Illinois Tollway Standard Drawing Revisions

Section C	Guardrail & Concrete Barrier			
	Standard	Modification Summary Effective: 03-01-2022		
	C3-09	CONCRETE BARRIER SINGLE FACE, REINFORCED TL-4, 44 INCH

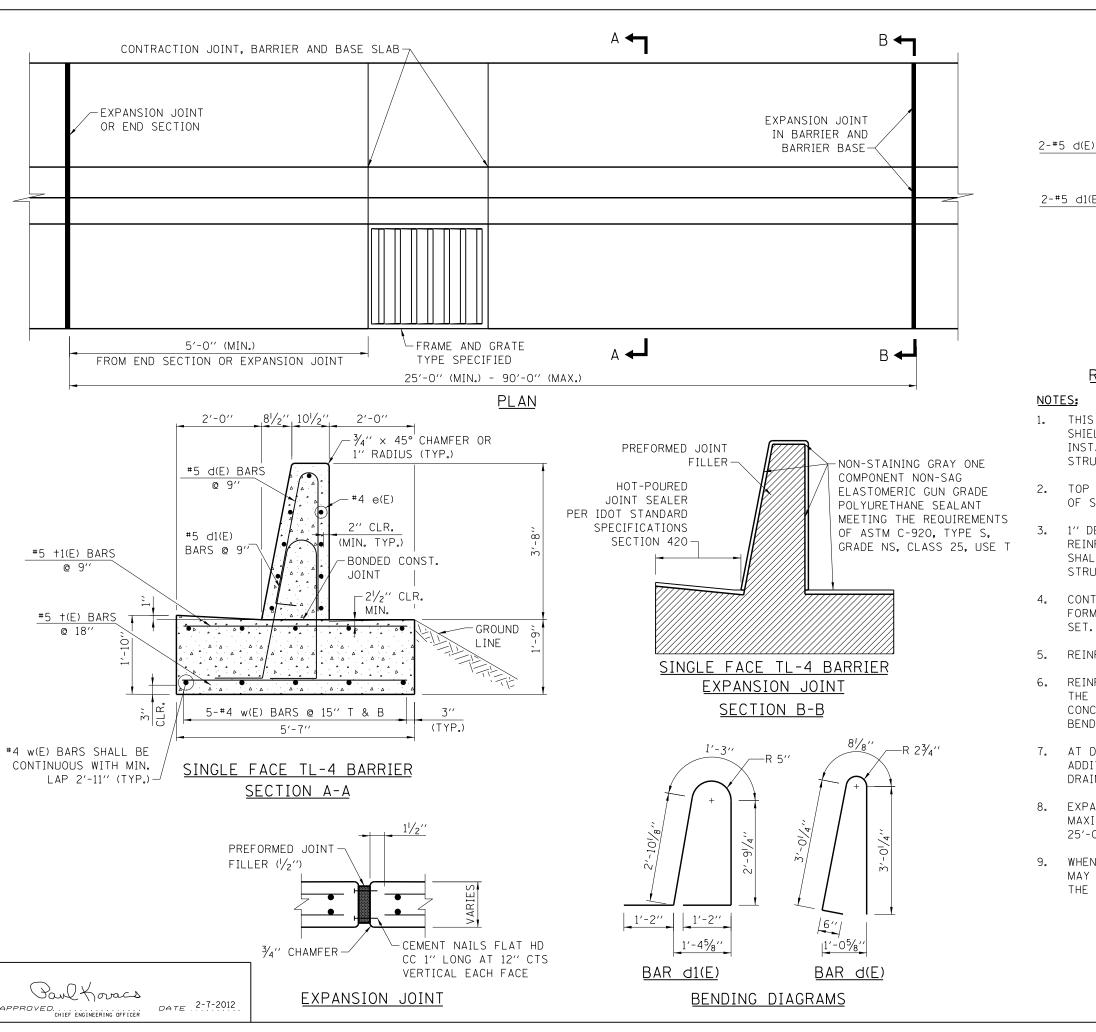
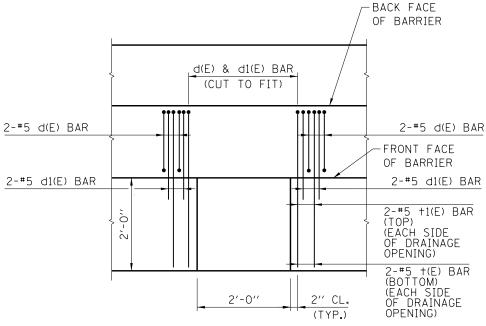
Sheet 1	Added hot-poured joint sealer call out to Section B-B. Added note #9 on fill behind backside of barrier base.		
	C4-11	CONCRETE SHOULDER BARRIER TRANSITION, TYPE V-SF

- 9. WHEN SPECIFIED IN THE PLANS, THE BACKSIDE OF THE BARRIER BASE MAY BE LEFT EXPOSED A MAXIMUM OF 1', MEASURED FROM THE TOP OF THE BARRIER BASE.

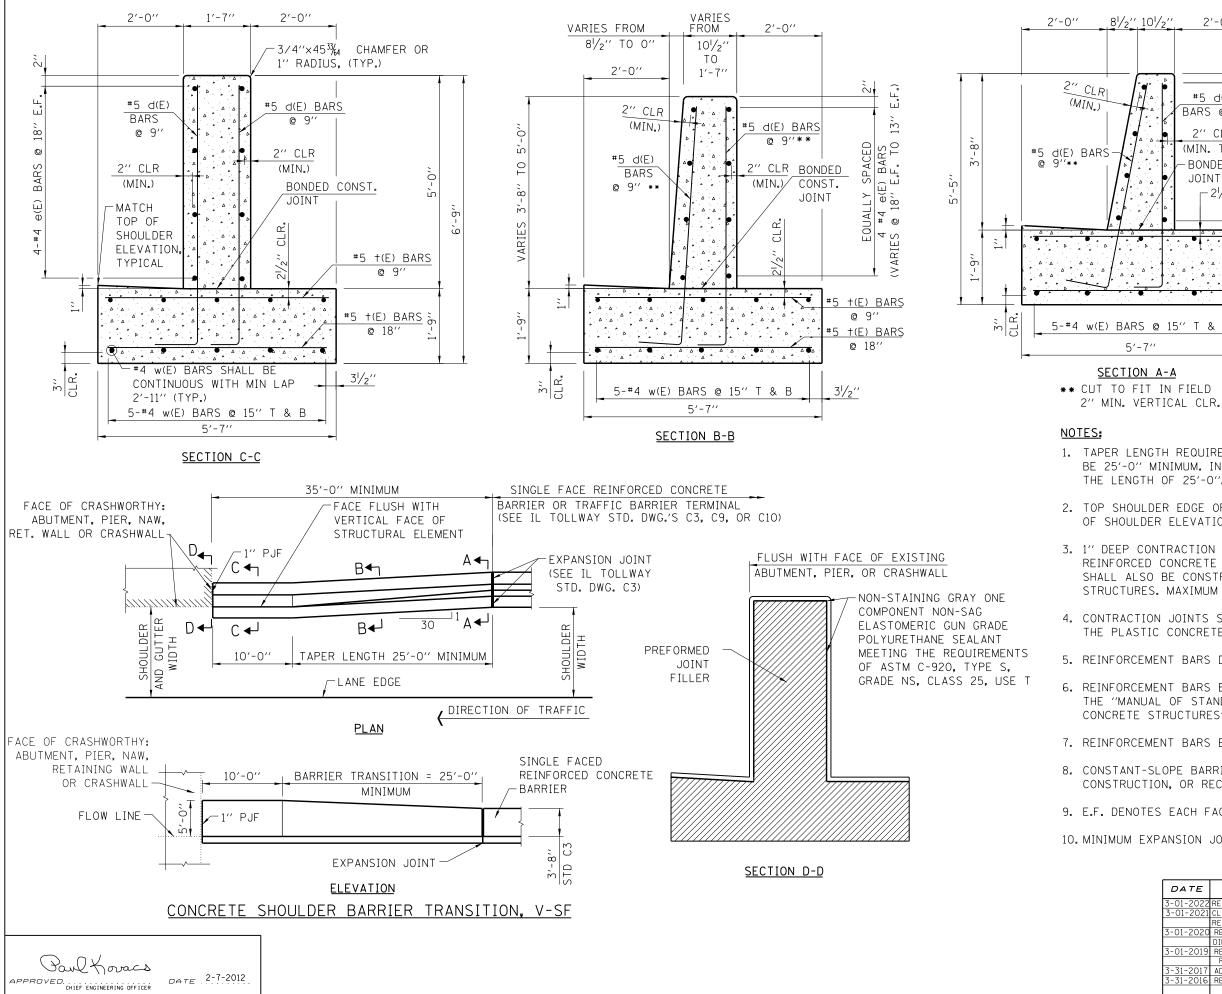
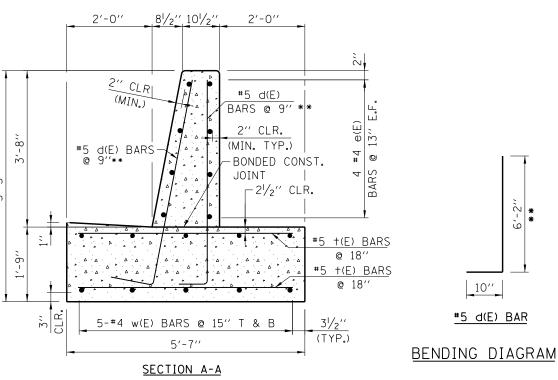
Sheet 1	Revised Note 4 describing how contraction joints shall be formed.		
	C13-07	CONCRETE MEDIAN BARRIER TRANSITION, TYPE V-DF AT BRIDGE PIERS		
	Sheet 2	Revised hot-poured joint sealer call out on Section A-A.		
	C15-02	CONCRETE BARRIER SINGLE FACE, REINFORCED TL-5, T-SHAPE 44 INCH

- 4. CONTRACTION JOINTS SHALL BE FORMED BY A GROOVE 1/8". EITHER IN THE PLASTIC CONCRETE OR SAWED AFTER THE CONCRETE HAS SET.
- 5. REINFORCEMENT BARS DESIGNATED "(E)" SHALL BE EPOXY COATED.

DATE	REVISIONS	Illinois Tollway
	REVISED NOTES & CALLOUTS REVISED TITLE & STEM THICKNESS	CONCRETE BARRIER SINGLE FACE, REINFORCED TL-5, L-SHAPE 44 INCH
		STANDARD C16-02

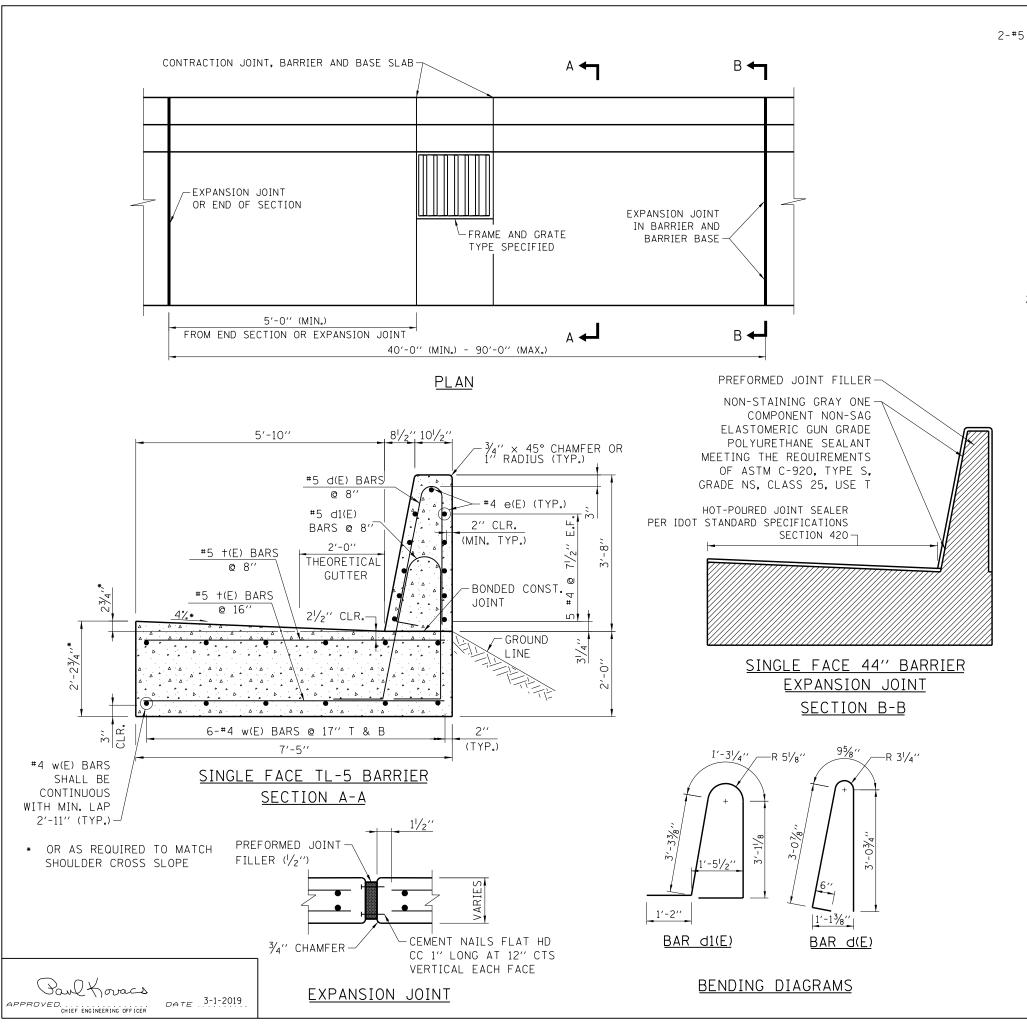
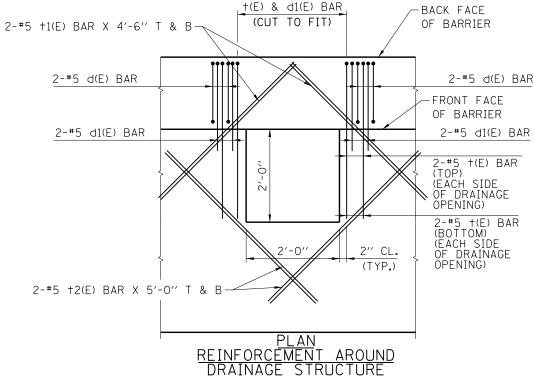
Sheet 1	Added hot-poured joint sealer call out to Section B-B. Added note #9 on fill behind backside of barrier base.		
	C17-03	CONCRETE BARRIER SINGLE FACE, REINFORCED TL-5, 54 INCH

- 9. WHEN SPECIFIED IN THE PLANS, THE BACKSIDE OF THE BARRIER BASE MAY BE LEFT EXPOSED A MAXIMUM OF 1', MEASURED FROM THE TOP OF THE BARRIER BASE.
